Project Name: Edendale Crossing

Description: Preliminary site plan approval recommendation and rezoning approval recommendation

RE: Edendale Crossing- Preliminary Site Plan Review – 3rd Review

**Preliminary Site Plan / Site Condominium / Planned Development Review
for
White Lake Charter Township, Michigan**

Existing Conditions Plan - Overall
"EDENDALE CROSSING" SITE CONDOMINIUM
PART OF THE SOUTHEAST 1/4 OF SECTION 29, T3N, R8E
WHITE LAKE TOWNSHIP, OAKLAND COUNTY, MICHIGAN

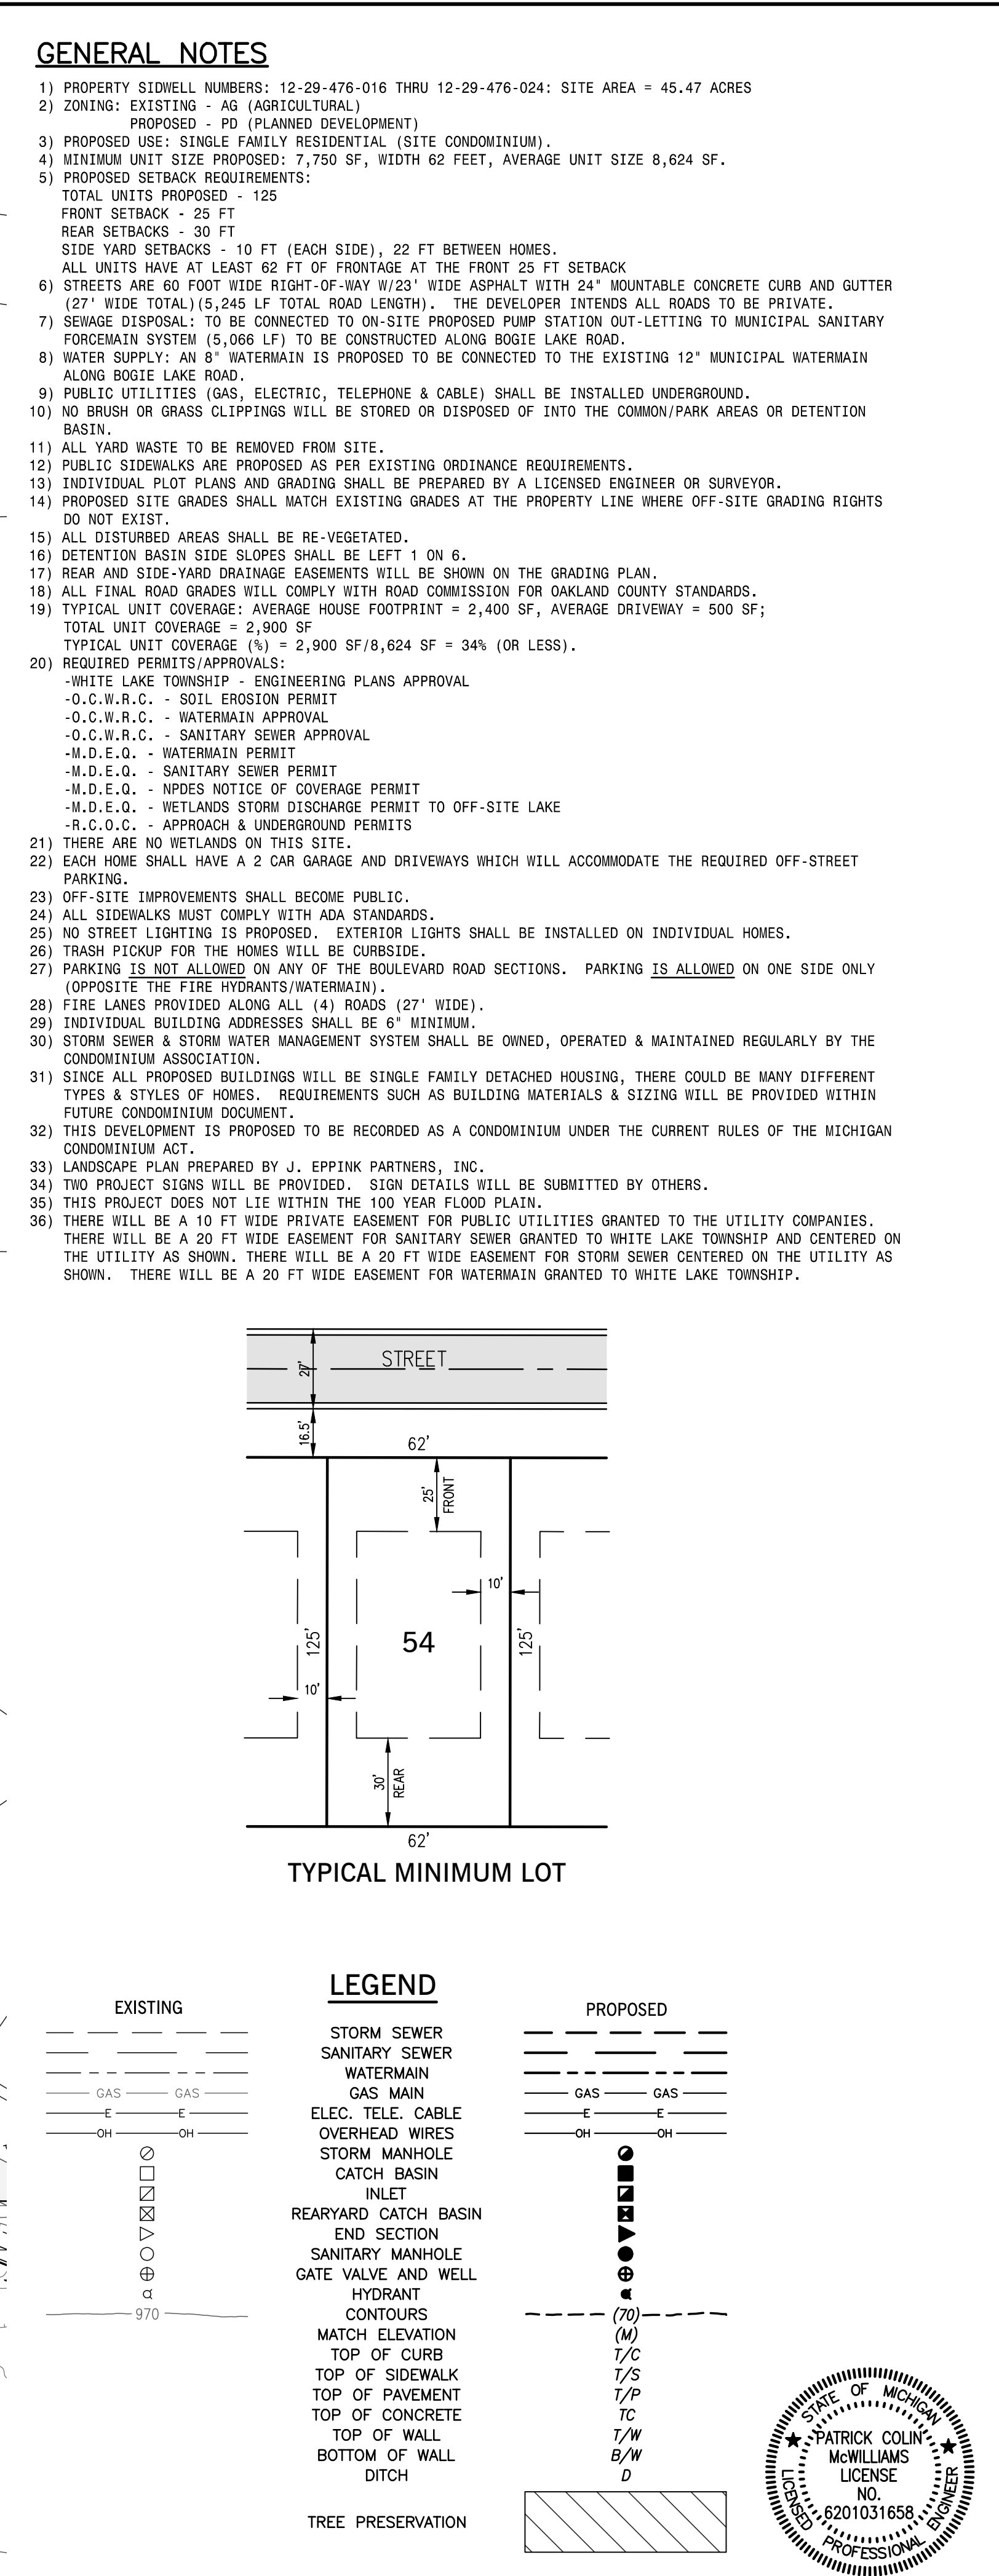
layout: The proposed 8' wide path along Cedar Island Road has now been shifted in its entirety to the north side of the road. The Existing Conditions Plan- Overall (Sheet 2) shows 43' existing ROW along Cedar Island Road in front of Parcel 12-29-476-007 while the Overall Site Plan and Notes (Sheet 3) shows the existing ROW in this area as 33'. Please clarify. The right of way along Parcel - 007 will determine whether a sidewalk easement will need to be granted by this property owner. Additionally, please revise '8' Wide Safety Path Connection to Huron Valley School Parking Lot' reference notes on Sheets 3 and 5 from Sheet 17 to Sheet 19.

8' WD. 4" THICK CONCRETE SIDEWALK
CEDAR ISLAND ROAD R.O.W.

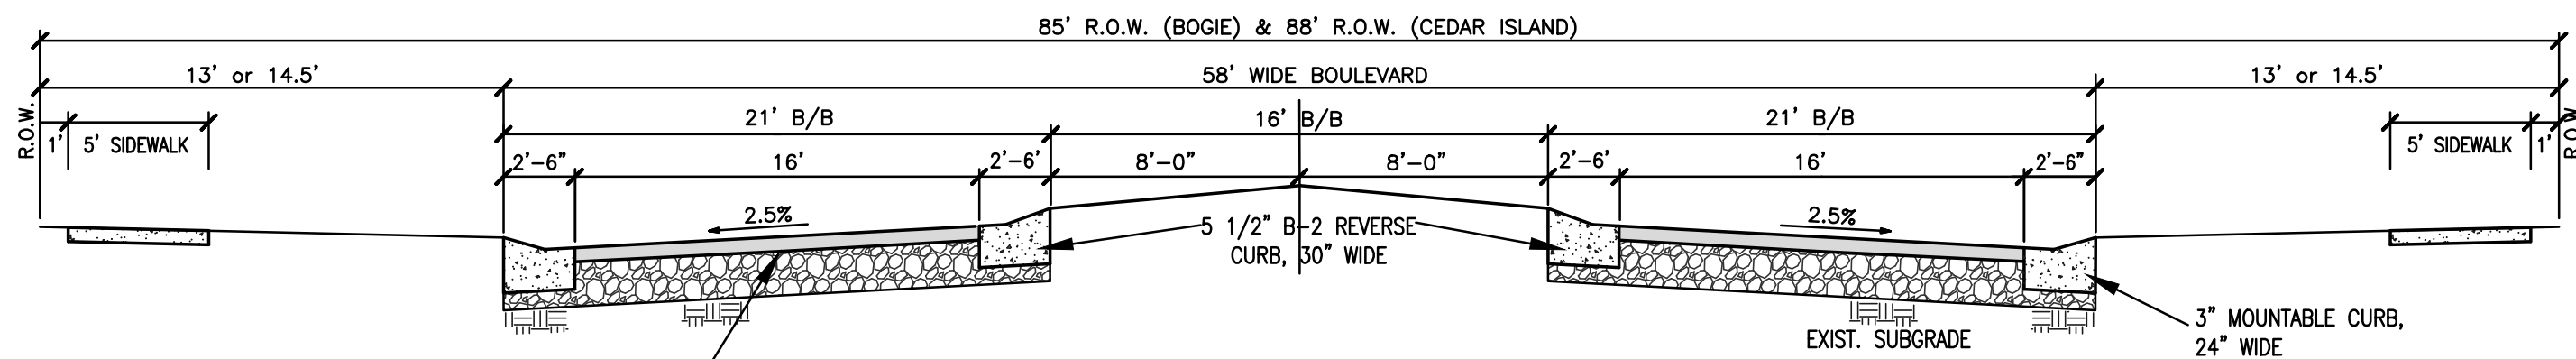
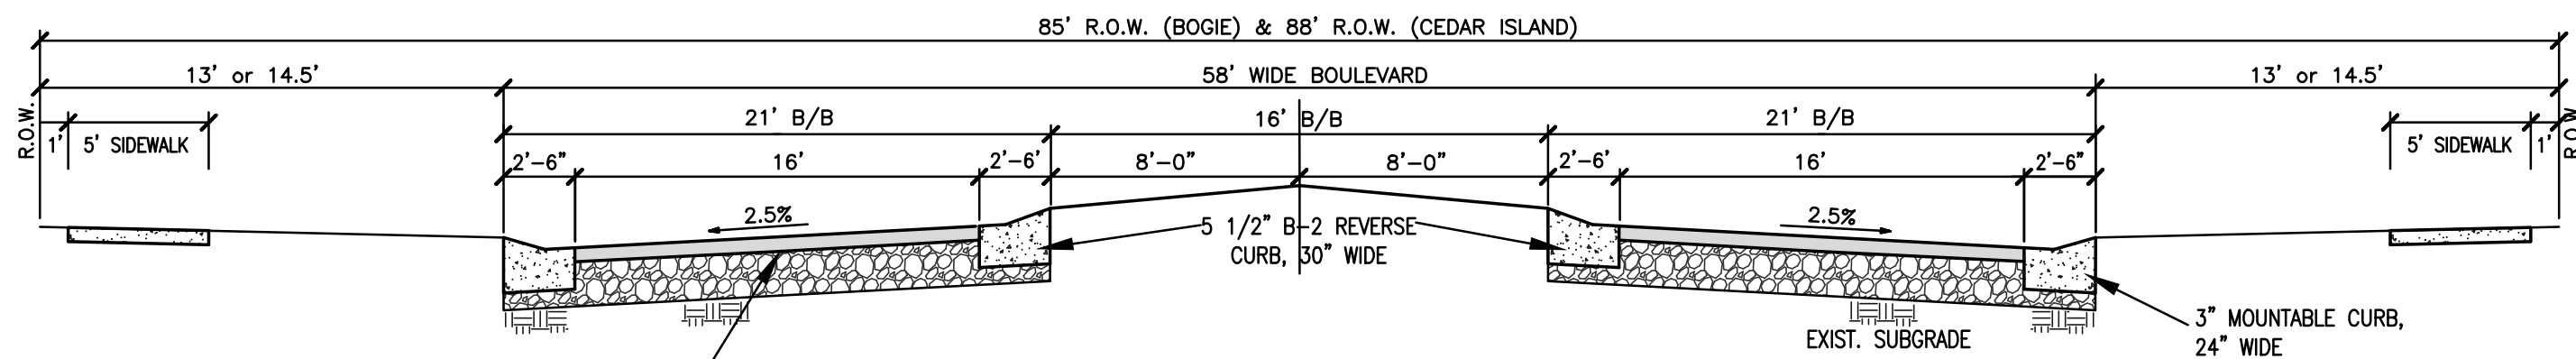
2. The proposed sidewalk along the Bogie Lake Road frontage measures 5' wide. A 6' width is required per Zoning Ordinance Section 5.21. Please call out sidewalk width on plan as well. Comment partially addressed. The sidewalk label has been changed to now show a 6' wide sidewalk; however, based on plan scale provided, the sidewalk width measures 5'. Please revise width to 6' based on provided scale. In addition, please add a detail for the 6' wide, 4" thick concrete sidewalk on Sheet 16. Also change the label '(onsite & Bogie Lake Road)' to '(onsite)' for the 5' wide, 4" thick concrete sidewalk detail. **Comment addressed. All requested revisions have been made.**
